Änderung des Durchmessers bei Bremsscheibe 92121103

Change of diameter with brake disc 92121103

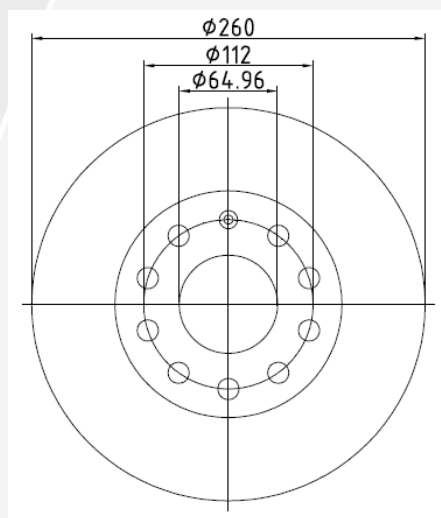
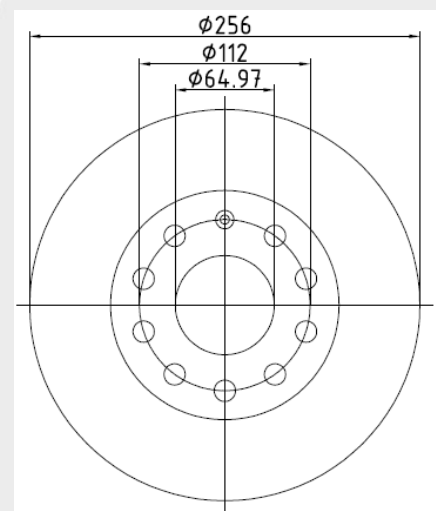
Dem Fahrzeughersteller (Volkswagen-Gruppe) folgend, wird der Durchmesser der Bremsscheibe 92121103 von 260 mm auf 256 mm reduziert.

Diese Veränderung der Dimensionierung erfolgt aufgrund von Korrosionsbildung am äußeren Rand der Bremsscheiben, welche in der Vergangenheit häufig zu Geräuschbildung und Beanstandungen bei Hauptuntersuchungen geführt hat.

Due to diameter modifications of the car manufacturer (Volkswagen-Group), the diameter of our brake disc 92121103 will be reduced from 260 mm to 256 mm.

This change of the dimension avoids corrosion at the outer radius, which in the past frequently caused noises, and led to claims in technical inspections.
